GLAST Large Area Telescope:

AntiCoincidence Detector (ACD) Configuration Change – Connector Placement

ACD Team
NASA Goddard Space Flight Center

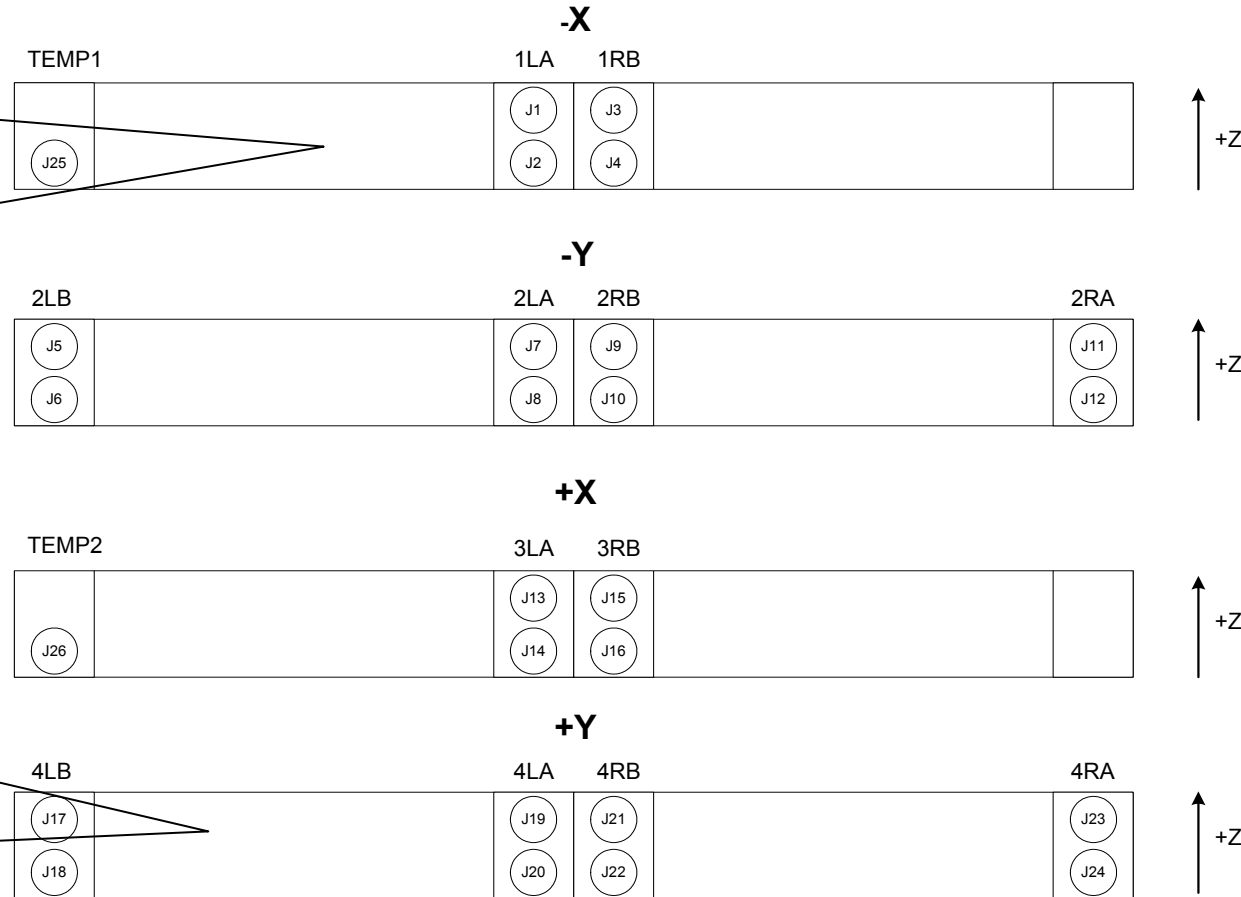
Problem is here: numbering of data channels requires a "left" FREE board, but the connectors on this type of board are on the left side, not the right side as shown.

Connector placement and tile to data channel mapping were completed well before FREE card channel layout. When FREE card design was done, did not cross-check for consistency.

CURRENT CONNECTOR CONFIGURATION

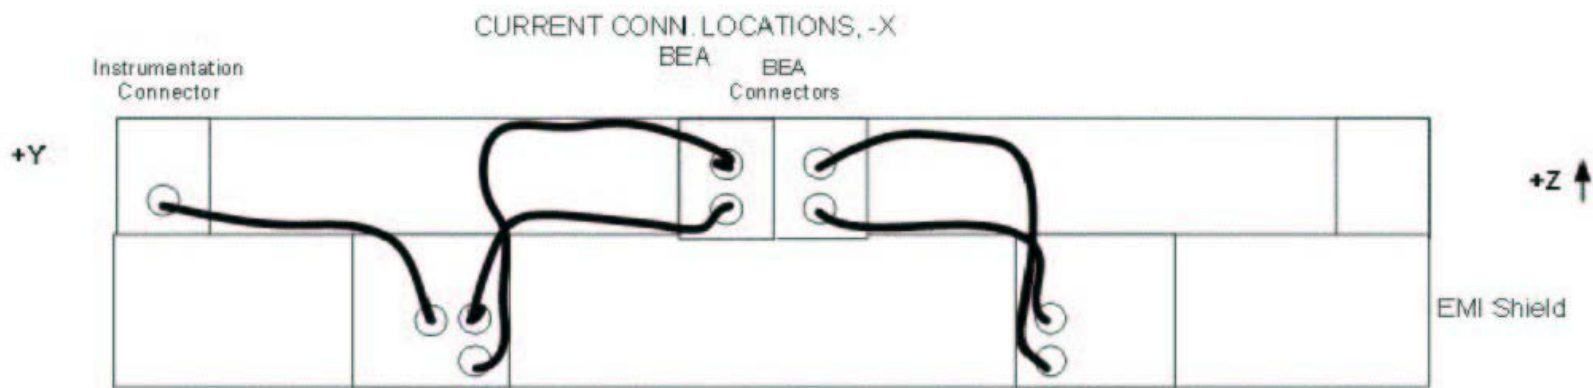
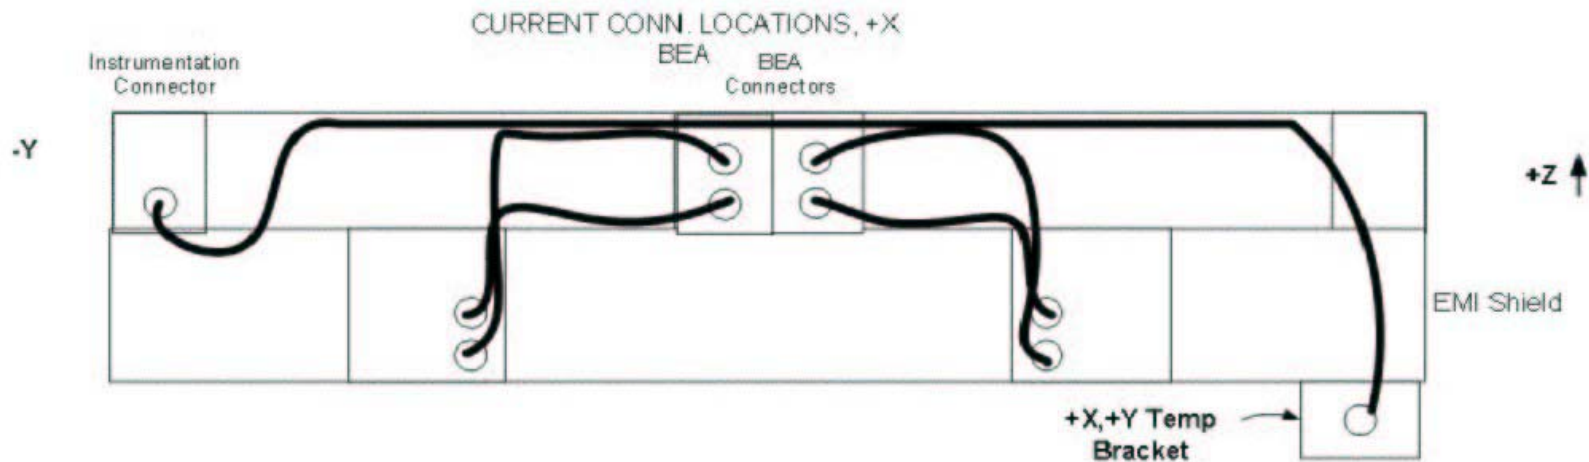
No problem on the Y side: two left boards and two right boards use all eight connector locations. Numbering matches ICD.

Moving connectors changes cable routing

BEA connectors move to left side

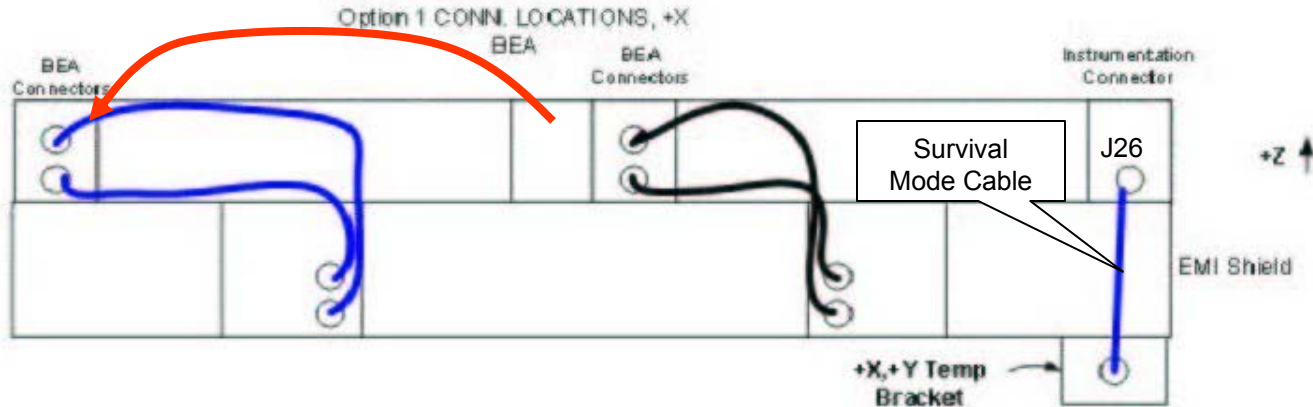
1. Switch to FREE card with correct channel numbering but with connectors to the left.

Instrumentation connectors move to right side

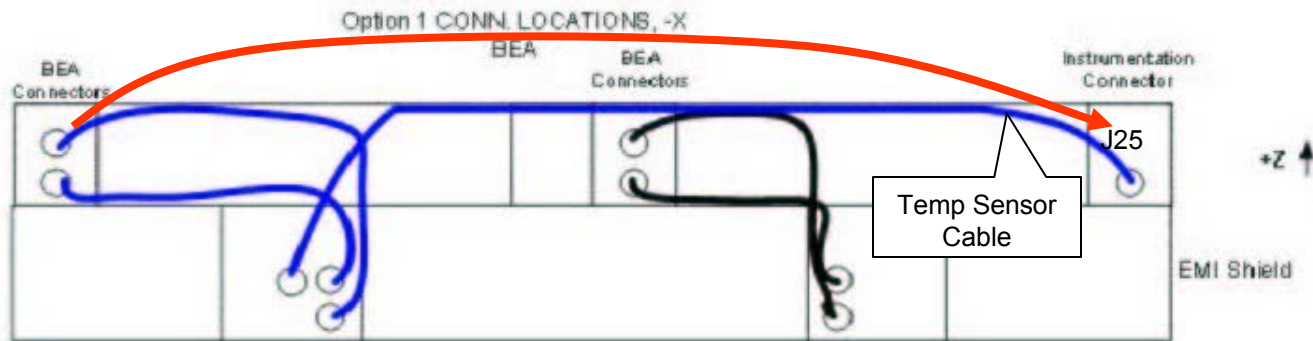
2. Move the instrumentation connectors to the right side

3. Re-route the cables across the BEA.
